OUR REF: 6228
YOUR REF: MCU/2023/471

RE: RESPONSE TO COUNCIL INFORMATION REQUEST

AT: 1-5 HOMESTEAD DRIVE, STAPYLTON QLD 4207 (LOT 101 AND 102 ON SP316137)

Figure 1: Proposed (top) vs. Amended (bottom) Northern Facade (GDP file, 2024)

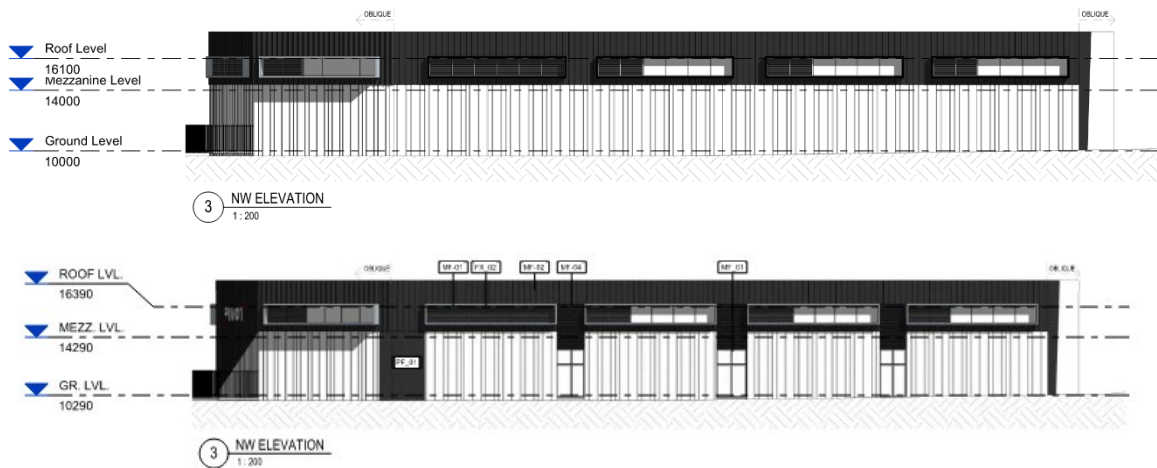
However, the warehouse facade facing the higher order Stapylton-Jacobs Well Road has substantially less articulation and materiality that results in a stark and austere appearance that does not meet Performance Criteria PC6 of the M38 Industrial Estate Place Code. To achieve the high standard of architectural presentation, the proposal is requested to:

- a. Incorporate additional feature elements that are consistent with the Homestead Drive elevation, such as a variation in the parapet height, additional wall blades and colours.*

In response to this item from Council, Amended Proposal Plans have been provided within **Attachment A**. These plans reflect a revised northern façade presenting a more articulated and interesting visual finish. The changes are compared in **Figure 1** below, with notable changes in colour and materials by way of vertical features elements between each unit windows.
